ENGINEERING REPORT

61 BUTLER RD, BOULDERCOMBE Q

Contract No. CE18014 - 1 into 4 Lot Subdivision – Engineering Report

Development Permit No.: D/20-2018

LOT 4 ACCESS LAYOUT
SCALE 1:500

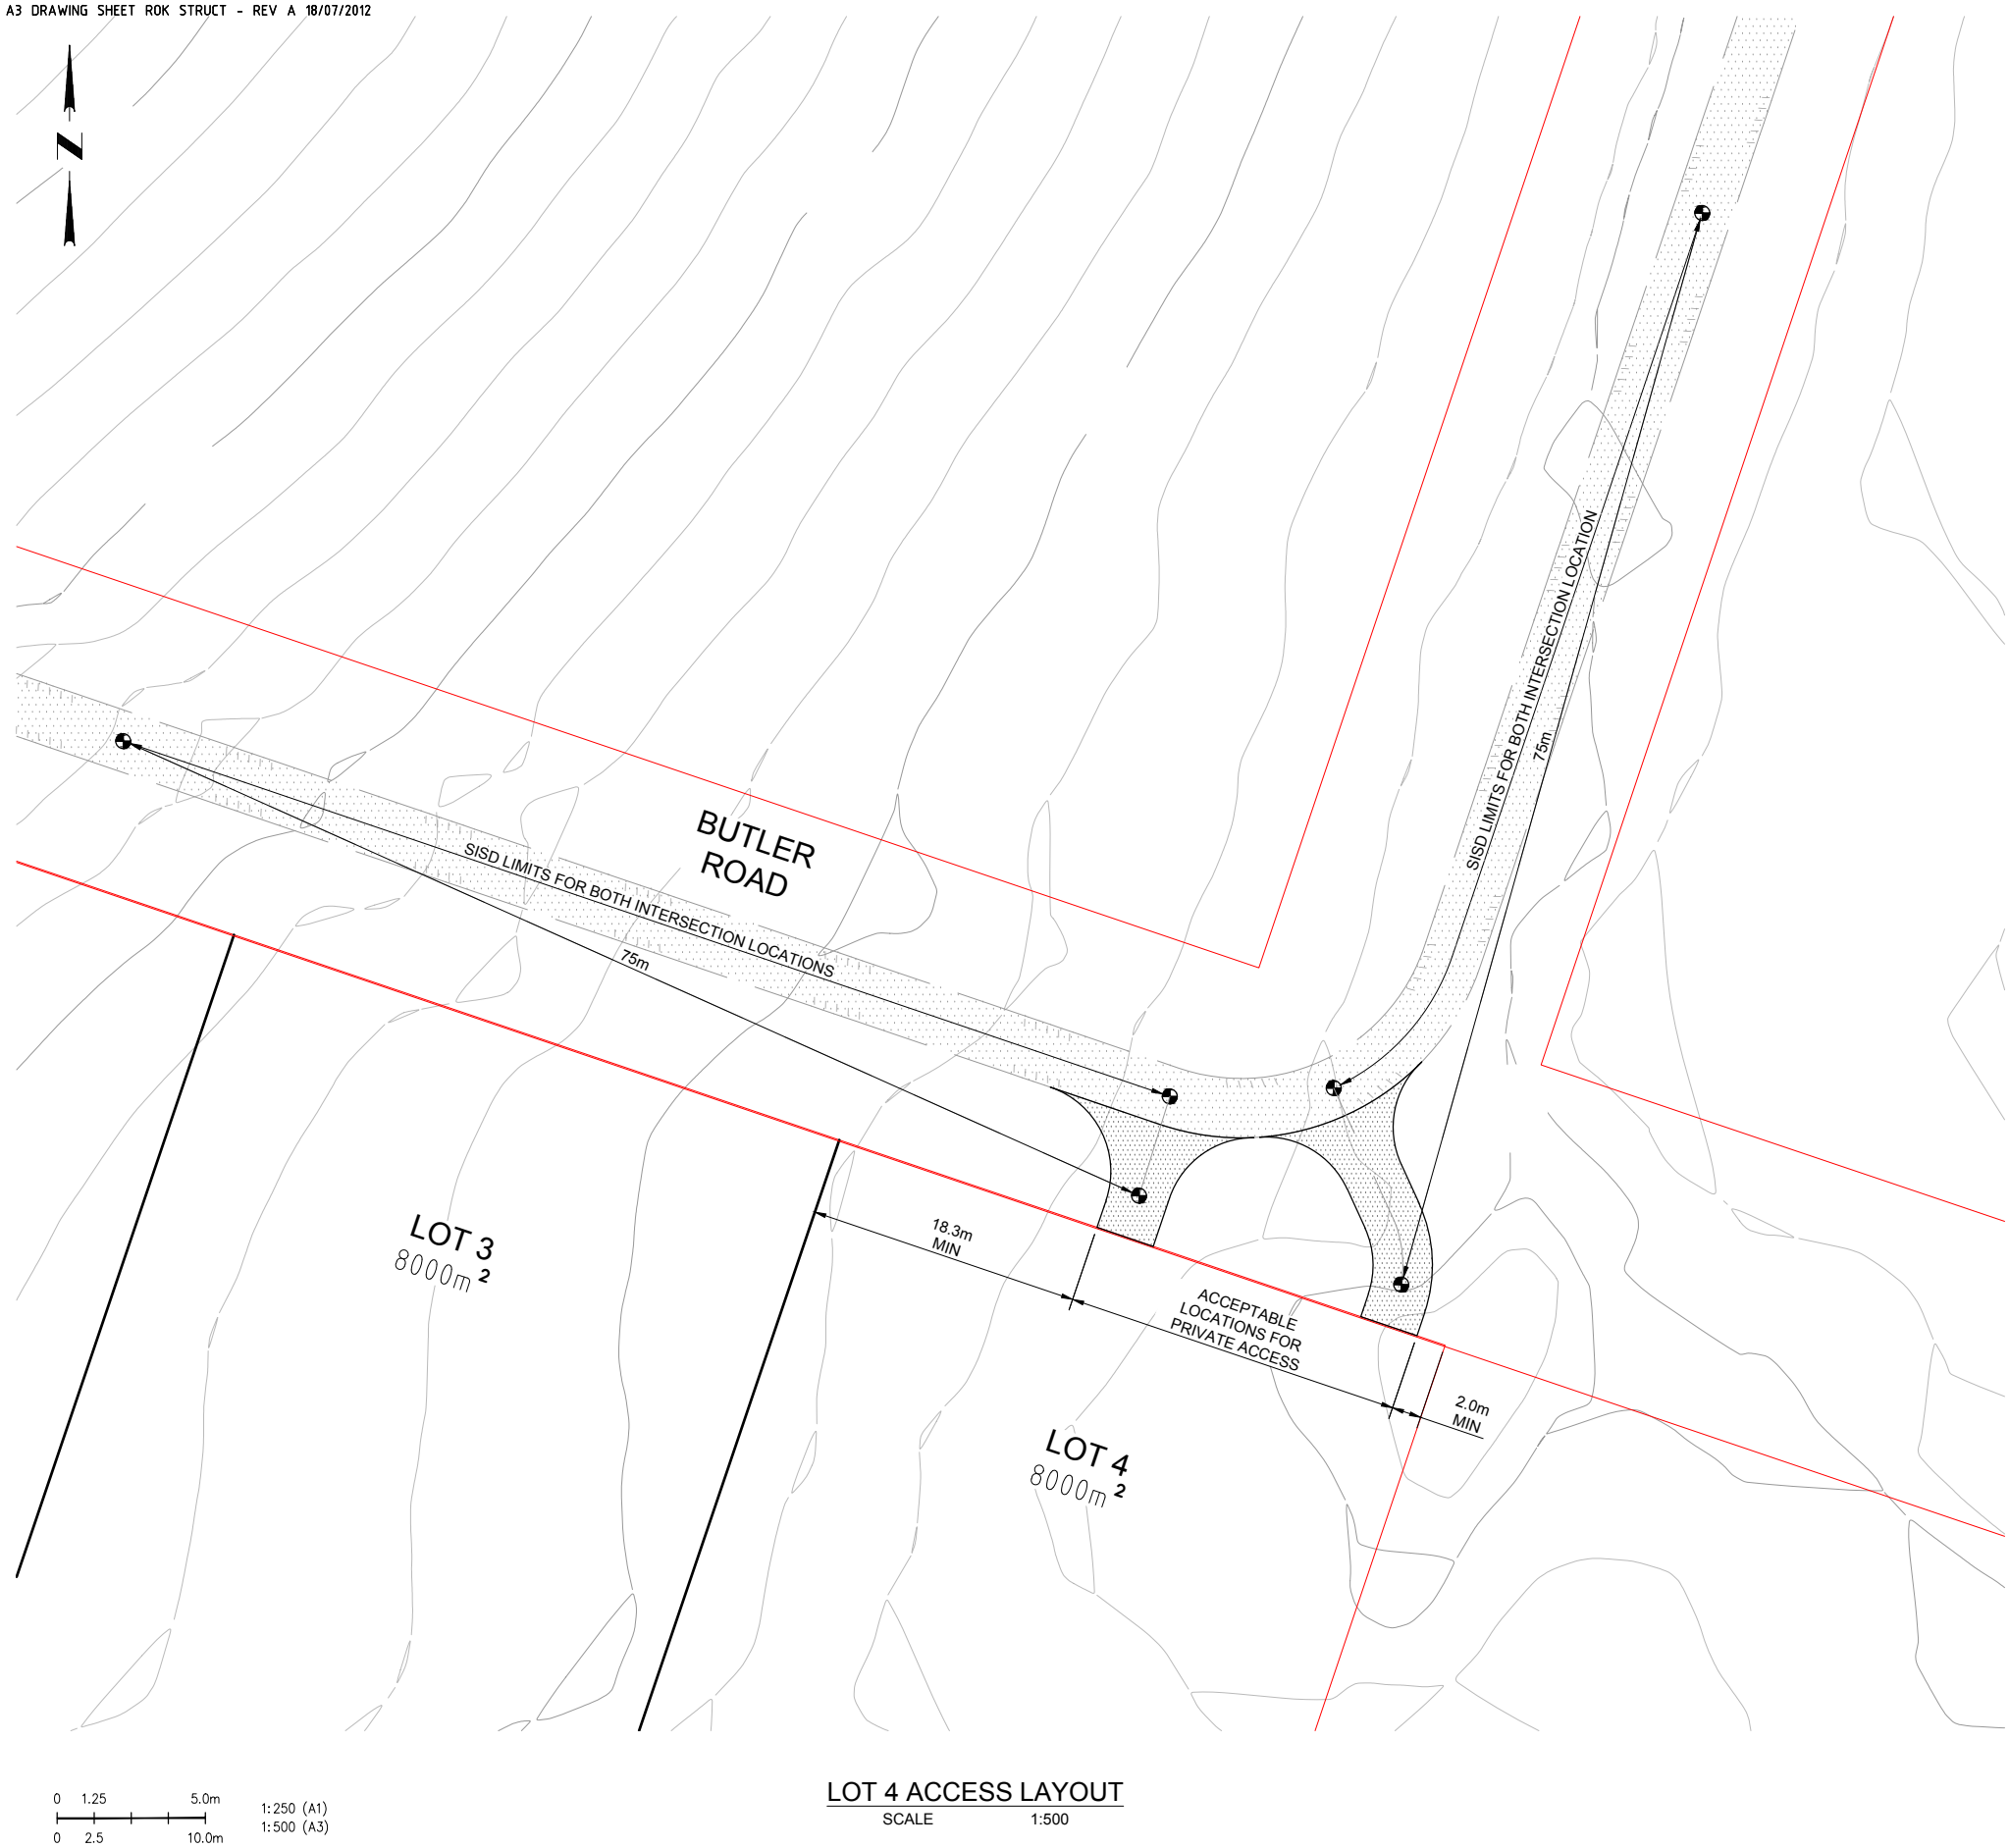
- 1.2 Provide an Engineering assessment to demonstrate that any future development on proposed Lot 4, complies with the Capricorn Municipal Development Guidelines requirements and particularly regarding sight distance in accordance with Austroad recommendations.

The proposed development currently fronts Butler Rd, along its complete northern boundary. Butler Rd is considered classified as an Access Place/Street, currently servicing five (5) separate dwellings. Butler Rd's profile consists of an approx. 4m unsealed graveled road with no formed table drains for the frontage of the development and a road corridor of 20m.

No posted speed signage is recorded on site for the full length of the Butler Rd, however a Design Speed of 40km/h has been adopted for the purposes of this study.

In accordance with Austroads Part 4A (*Unsignalised & Signalised Intersections*) the Safe Intersection Sight Distance will be adopted as 75m, rounding to the nearest 5m from the calculated 73.3m.

Please refer to APPENDIX B (CE18014-004) for illustration of the suitable driveway access location in accordance with the abovementioned SISD parameters.

Scale: 1 : 1000 @ A3	Drawing No: 18072-PP-01
Drawn: AD	Sheet: 1 of 1
Surveyor: N/A	Revision: B

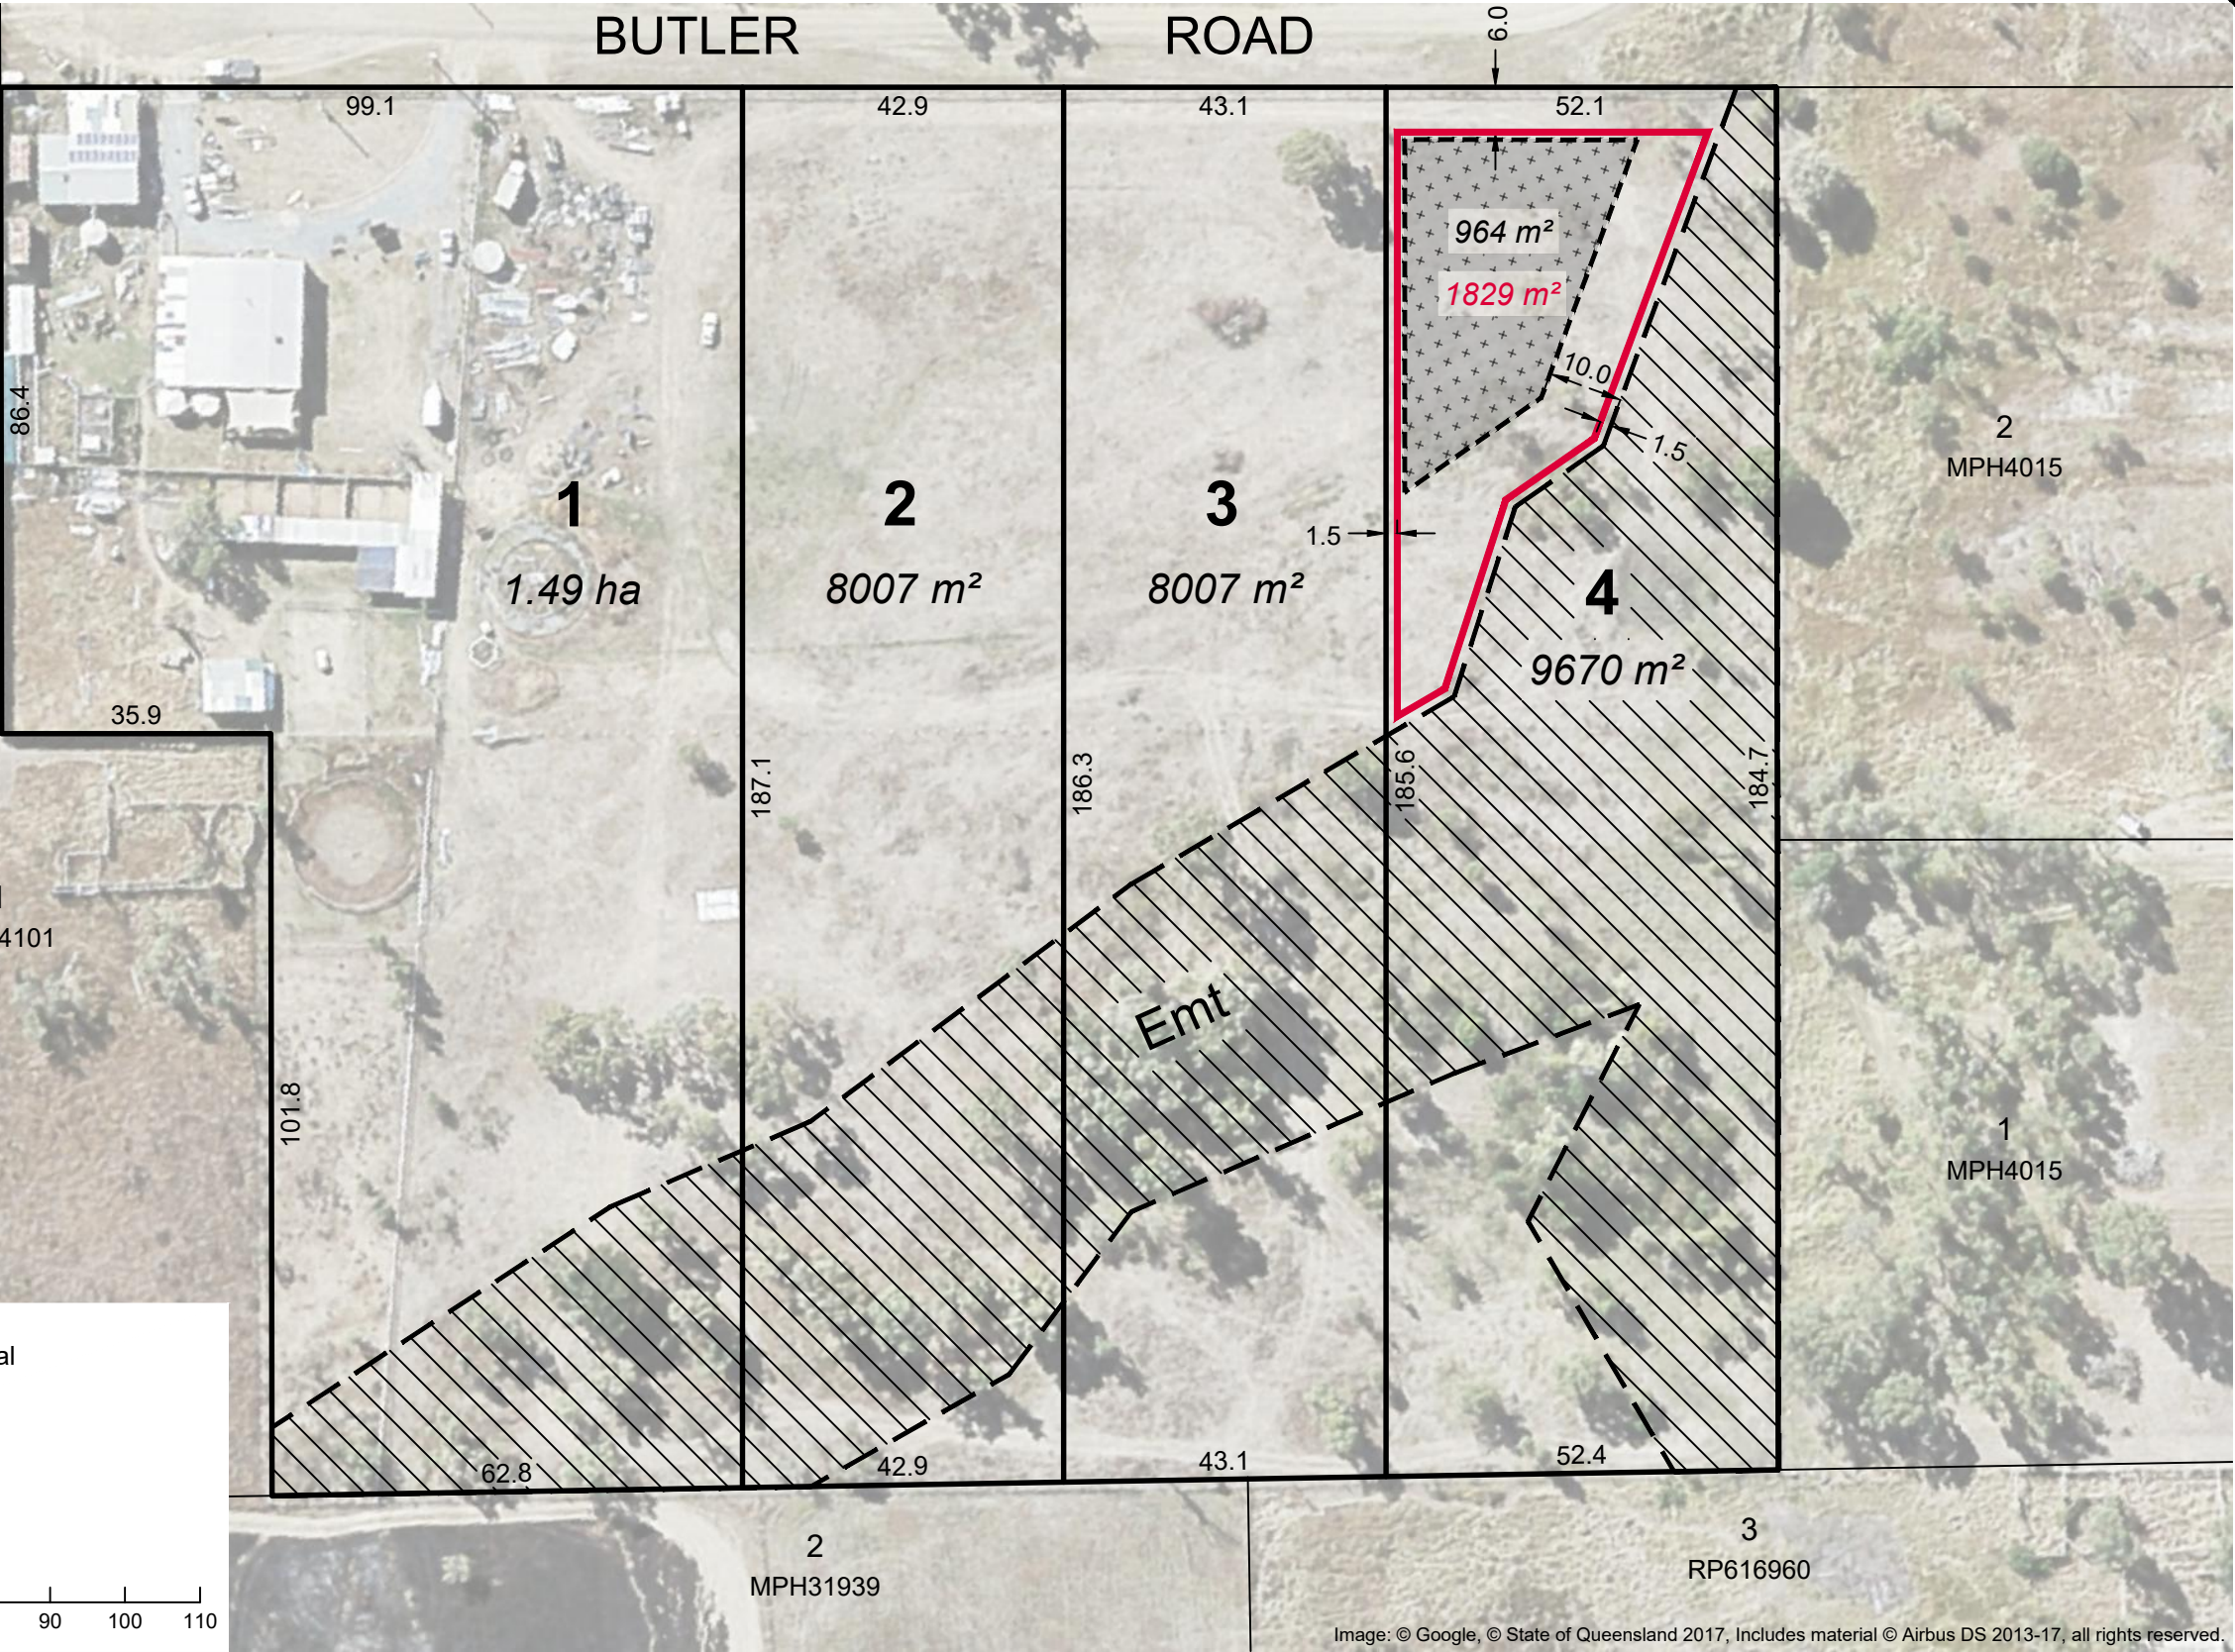
As per Item 1.1.3 of the RFI by RRC, the proposed 1 into 4 Lot subdivision will require that there be a dedicated easement drawn to encompass the full extent of the 1% ARI event.

It has been adopted at the request of the property owner, that the dedicated easement in favour of RRC be drawn over the existing 1% ARI flood event extent demonstrated on drawing CE18014-003. Therefore, from this impact plot it can be confirmed that the shallow 1% ARI flood event can be conveyed within the easement defined in APPENDIX D (18072-PP-01 Rev B by Vision Surveys), as per Item 1.1 of the RRC RFI.
